Kevin Bilash  
US Environmental Protection Agency Region III  
1600 John F. Kennedy Boulevard  
Philadelphia, PA 19103

February 3, 2023  
File No. 4862.10

Re: Revised Responses to USEPA's October 13, 2022 and December 15, 2022 Comments  
Concerning the September 2022 IM Monthly Progress Report for AOI 7 in MHT

Figure 18

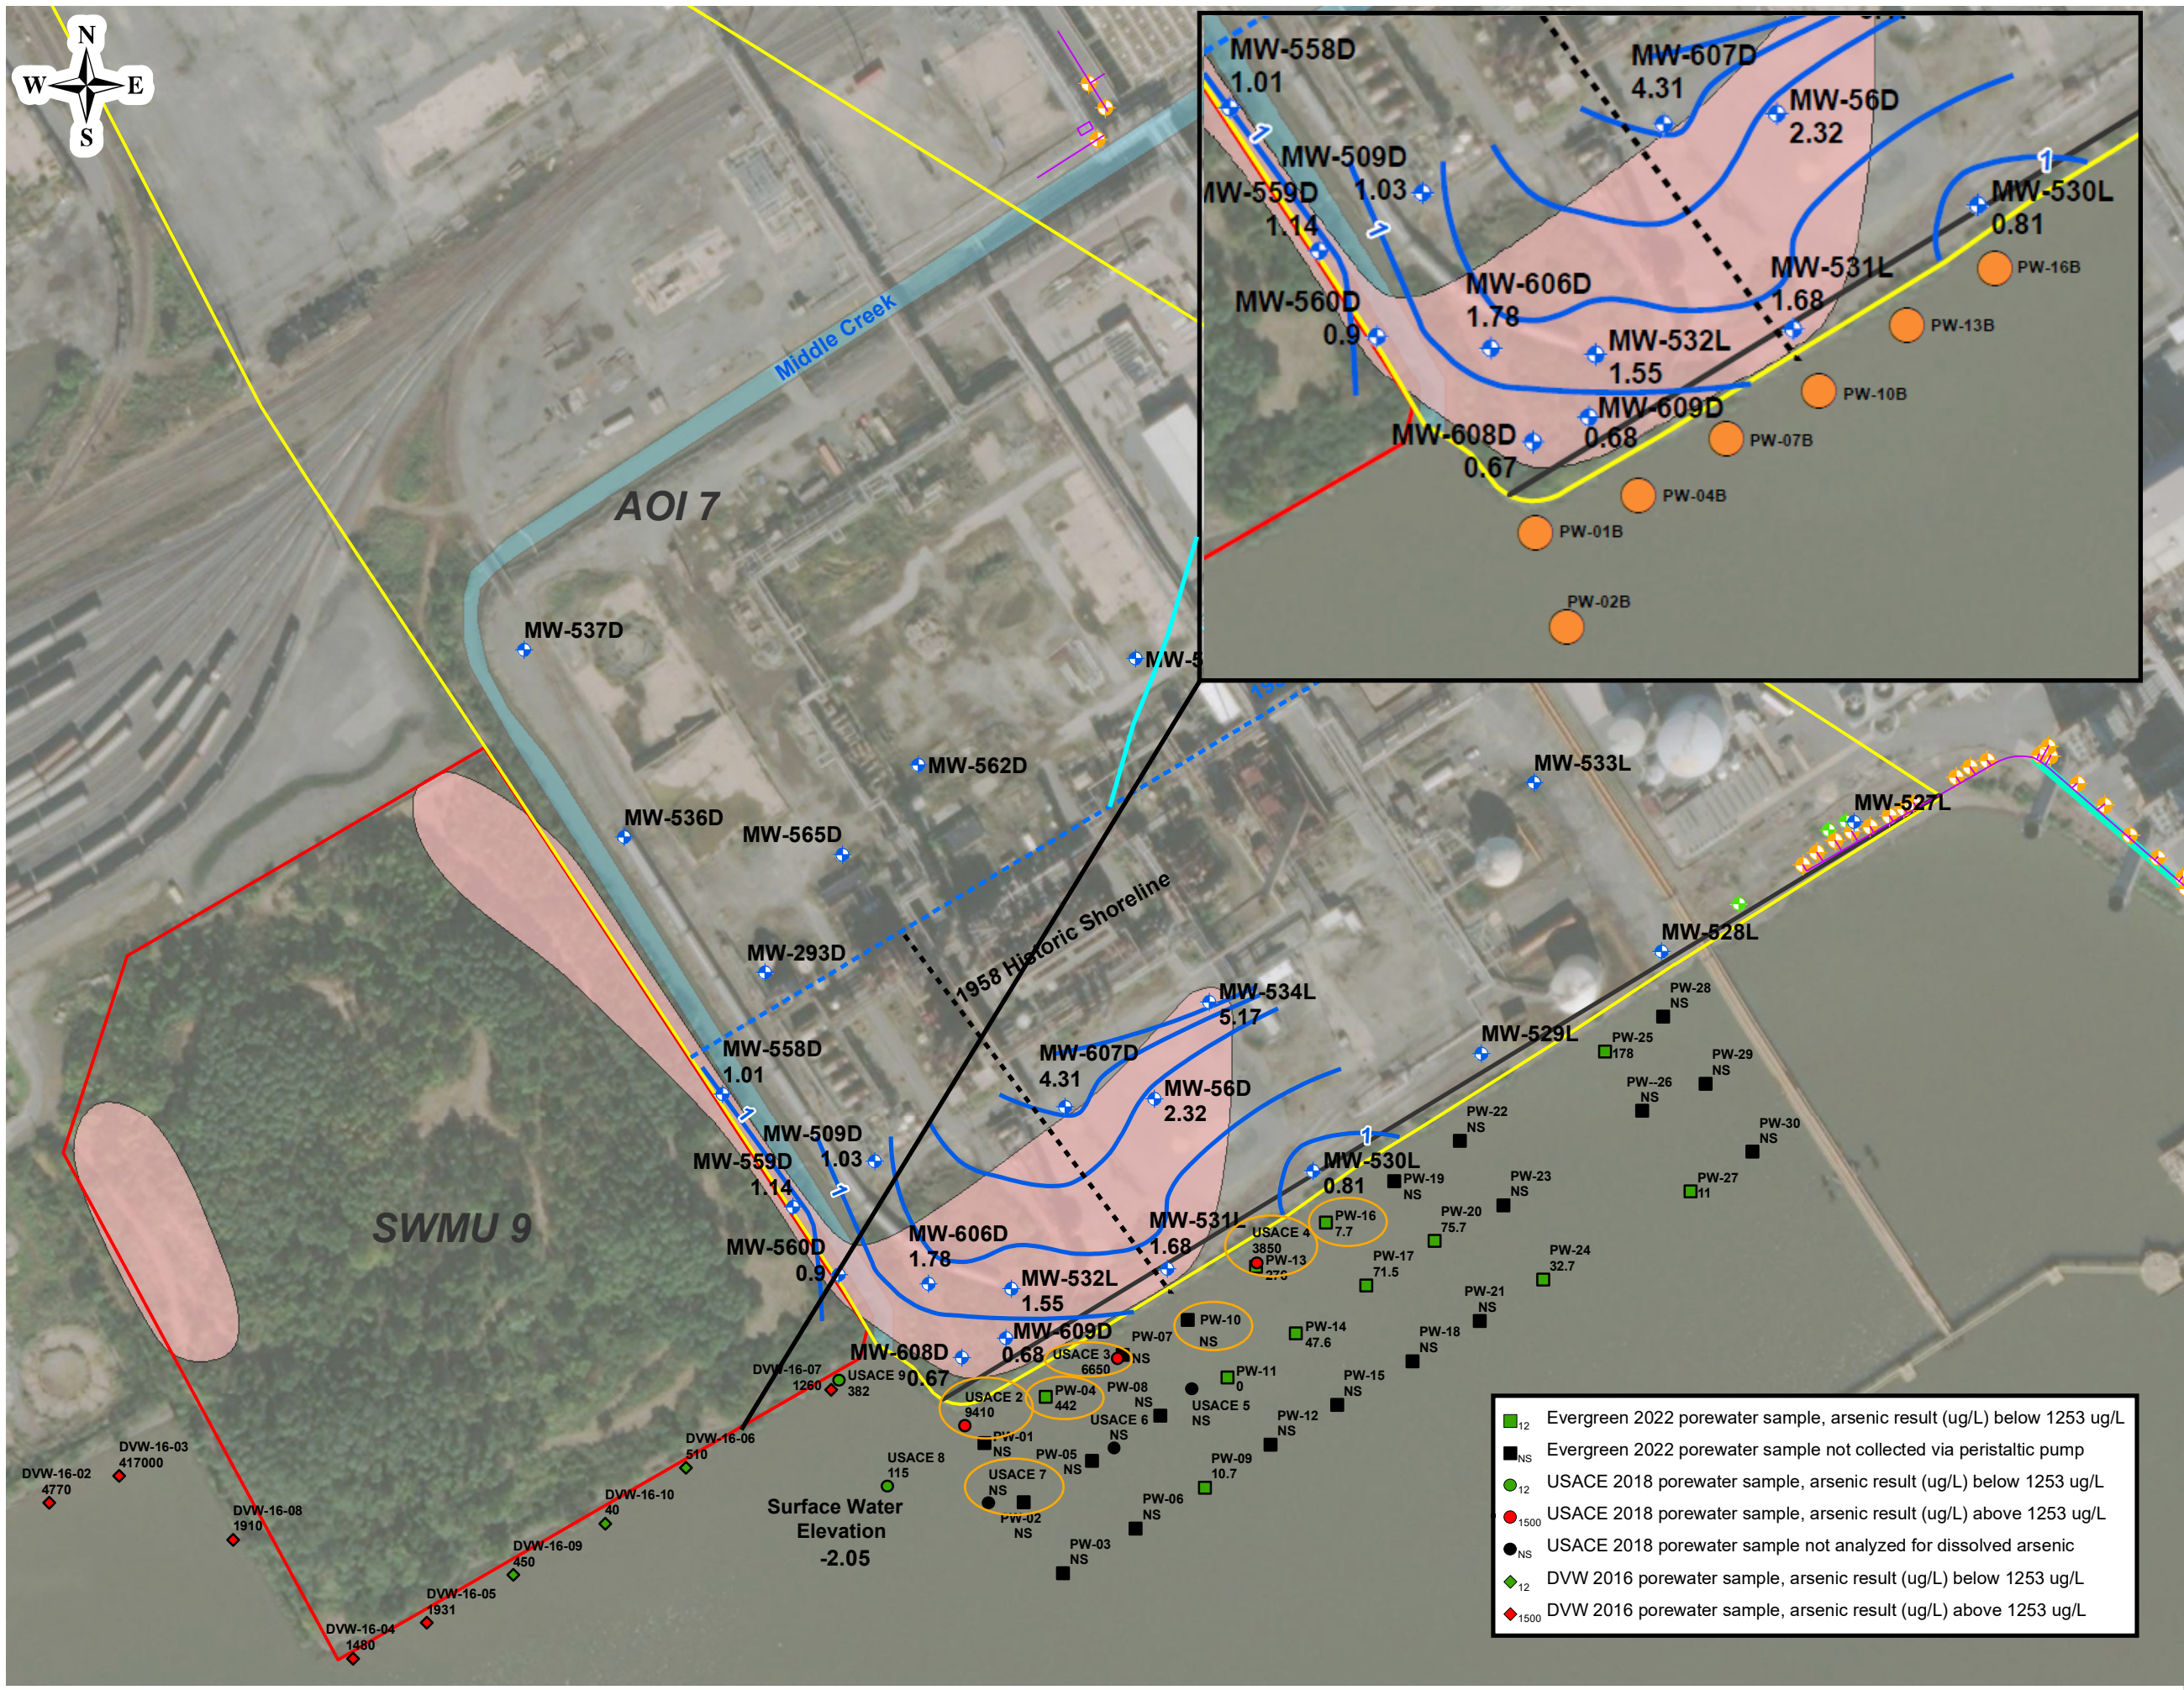
**Comment 6:** *Figures 16-18: Revise sample identifiers from ND to NS.*

**Response to Comment 6:** Figures 16-18 have been revised (see Attachment F) to reflect any porewater locations that were not sampled to be designated as “NS” instead of “ND”.

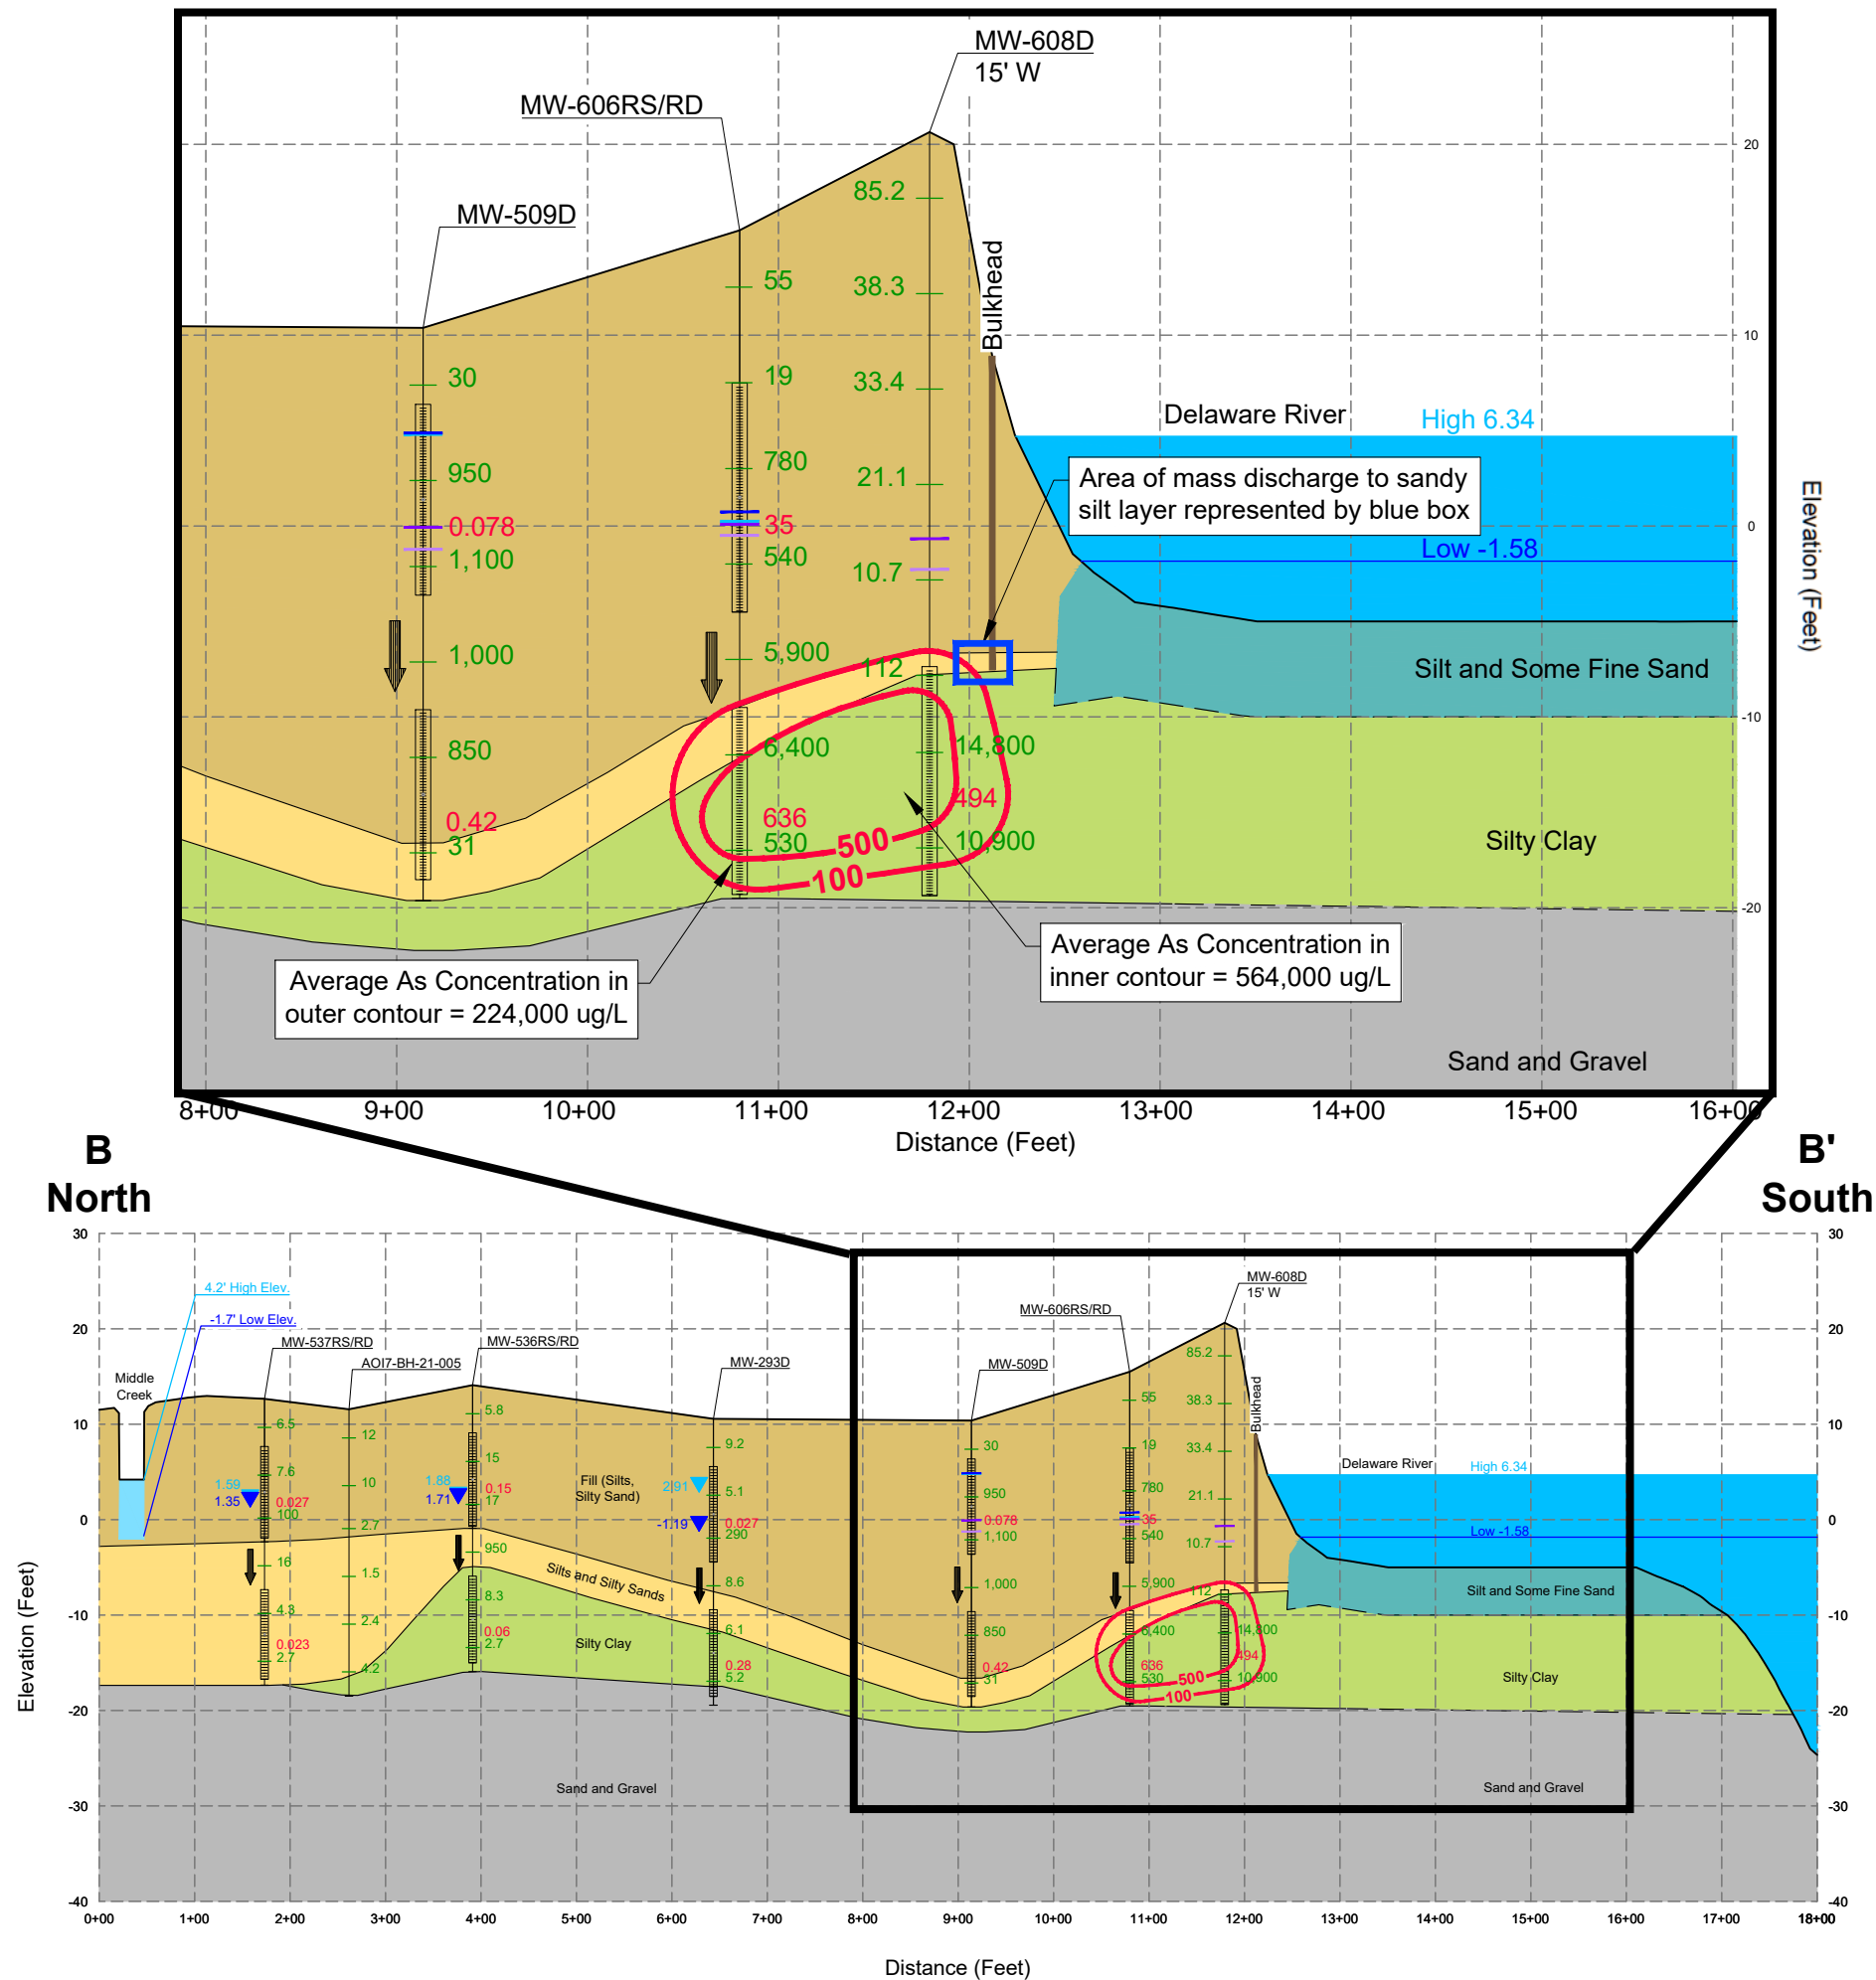
**Comment 1:** *Discussion 2.1. Equation 1 table As groundwater conc. CGW and Area show value “based on cross section” but no actual value reported. Please provide input values and supporting calculations. Back calculating using a presumed Area of 18 ft<sup>2</sup> yields a CGW of approximately 113 mg/L. If correct, this value appears low and would not support the statement that calculated arsenic mass discharge represents the highest Arsenic concentrations across the plume or that it represents a worst-case estimate.*

**(A)** The geochemistry conditions in the sediment-surface water interface is not anticipated to result in deposition of arsenic from porewater discharge as shown in the Geochemist’s Workbench modelling in Attachment E. However, to respond to Comment 1 above, the mass discharge near the bulkhead was calculated. The mass discharge calculations (including input values and supporting calculations) are provided in Attachment G. The mass discharge calculations provided in Discussion 2.1 in the Equation 1 table (Attachment E) utilizes the average weighted arsenic concentrations of the entire plume near the bulkhead and the area of the sandy silt layer as shown in Figure 1 in Attachment G. The results of these calculations indicate that the mass discharge would be approximately 0.039 g/d. The timeframe to reach
